Informational Bulletin No. VR20080610
Subject: Transport Bracket
Model: P33/24 HHM/FCR
Product Group: Vibratory Rollers
Date: 06/10/08

INFORMATIONAL BULLETIN **Group: VR**

Rammax Vibratory Roller Transport Bracket

Machines Affected:
ALL P33/24 HHM/FCR

Figure 1

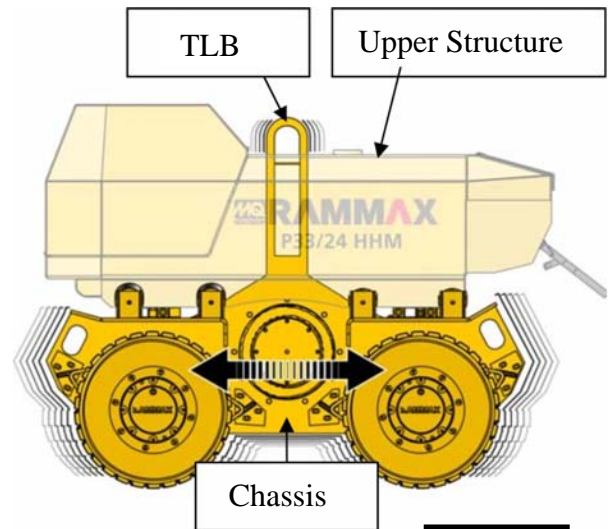
The transport bracket (TLB) required for lifting or transport must be able to vibrate freely at all times during operation of the machine (Figure 1).

Any lifting gear used for transport must be immediately removed on completion of the transport/lift operation. Lifting gear of any kind remaining attached results in frame or transport bracket damage.

Figure 2

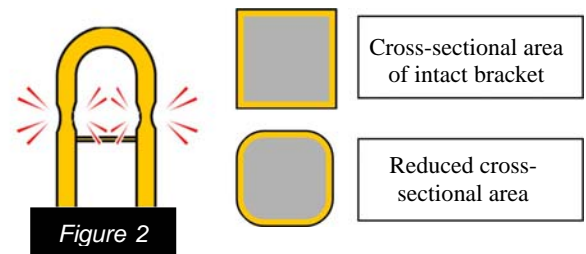
If any lifting gear is left attached to the transport bracket during operation of the machine, it will constantly vibrate against the transport bracket. Material will thereby be worn away, thus decreasing the load limit by reducing the material cross-section (Figure 2).

Figure 3

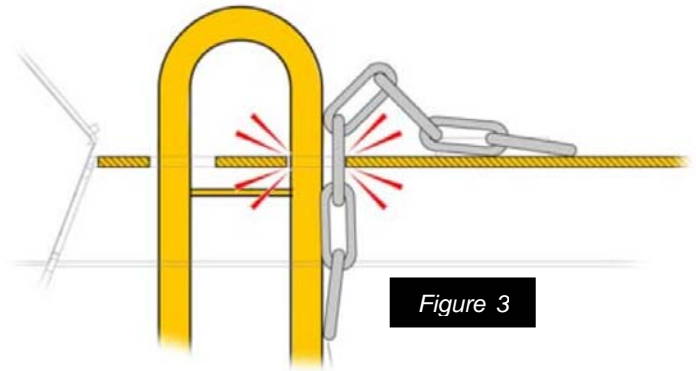
The area underneath the transport bracket is protected against the ingress of foreign matter and dirt by a foam insert. Lifting gear attached to the machine can damage the foam insert. As a result, lifting gear (chains, ropes) can be trapped between transport bracket and upper structure (Figure 3). If the bracket can no longer vibrate freely together with the chassis due to the trapped lifting gear, it will result in material fatigue at the weld seam (Figure 4) and adds strain to the components. This can lead to cracking of the transport bracket and in the mounting frame of the chassis around the flyweight housing (Figure 5).
